CITY OF ALBUQUERQUE

RE: **2100 Osuna NE**
Grading Plan Engineer's Stamp Date 8/1/17
Drainage Report Engineer's Stamp Date: 9/1/17
Drainage File: E16D001

Based on the information provided in your submittal received 9/11/17, the Grading Plan and Drainage Report cannot be approved for Building Permit until the following are addressed:

Profile View

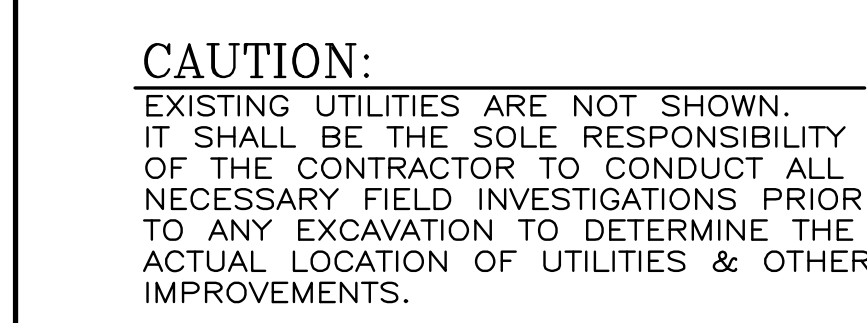
1. How does Lot 1B (to the south of this site) drain? It appears to drain to its NE corner and onto the SW corner of your site. Provide additional discussion regarding this. If there are off-site flows, these will need to be routed across your site as well.
2. The Stormwater Studio appendix does not match the grading plan with respect to slopes and inverts of the drain pipe.

ENGINEER'S SEAL  8/1/17	2100 OSUNA		DRAWN BY WCVJ
	GRADING AND DRAINAGE PLAN		DATE 8-07-17
			21724-LAYOUT-3-24-17
DAVID SOULE P.E. #14522		<i>Rio Grande Engineering</i> 1606 CENTRAL AVENUE SE SUITE 201 ALBUQUERQUE, NM 87106 (505) 872-0999	SHEET # —
			JOB # 21724

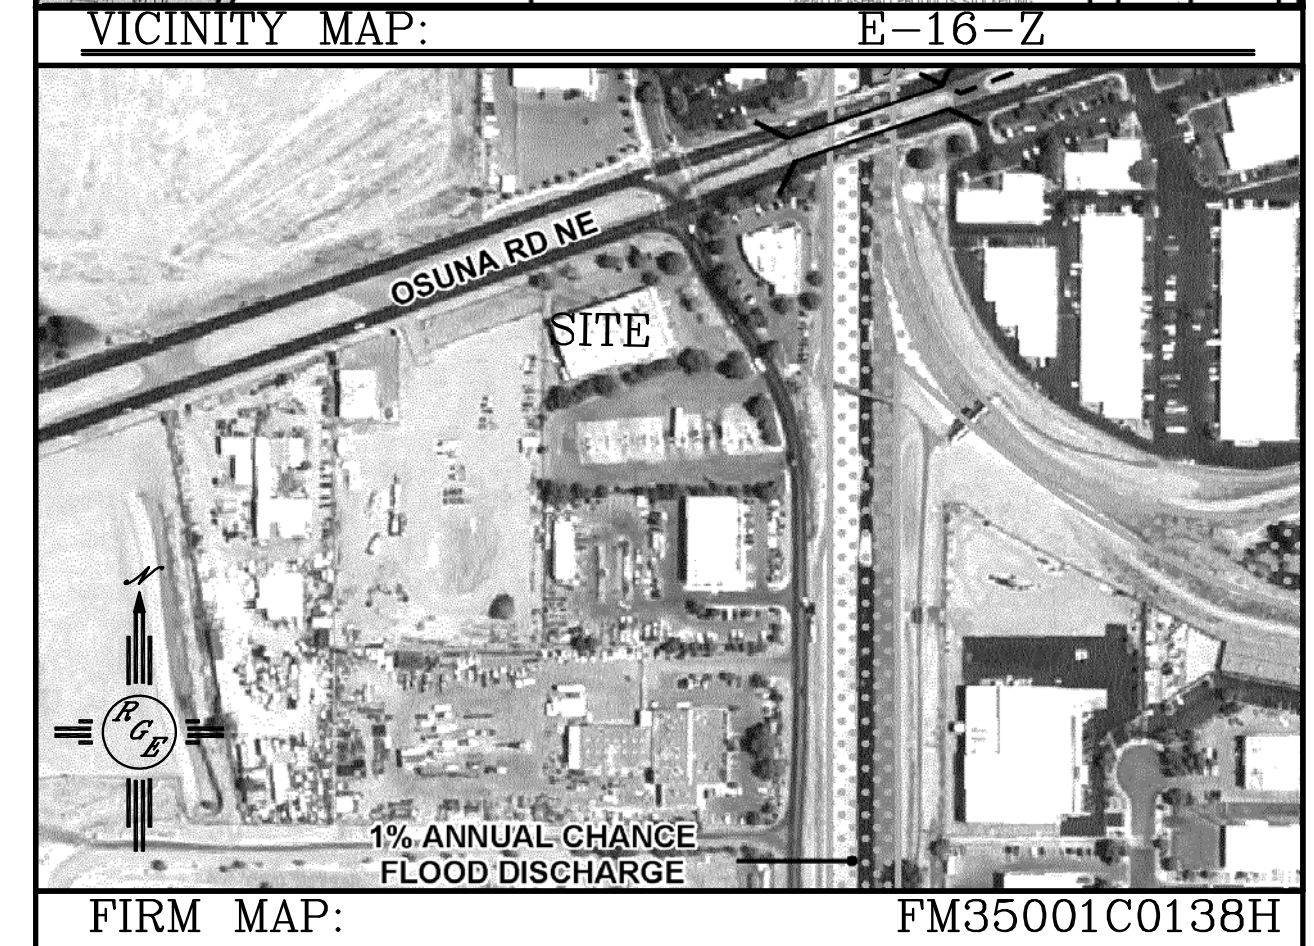
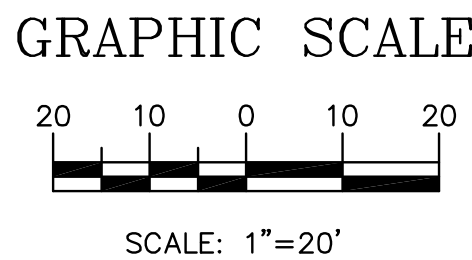
1. Laying the storm drain pipe at a 0.35% slope does not seem constructible; a slope closer to 1% is recommended.
2. Provide a detail for the outlet/reducer/drain grate at the SW pond.
3. Modify the linetype for the existing contours so they stand out from the proposed contours. Add contour labeling to both.
4. Extending existing topo south and west of the SW pond. It is unclear what flows may be entering/existing at this corner.
5. Clearly define the overland flow-path (emergency overflow) from the SW pond to Osuna. Include elevations, dimensions and erosion protection.
6. Provide a section view through the retaining wall.
7. An additional curb cut and grade break at the new entrance appear necessary at the small NW pond to route flows into the pond from the parking lot:
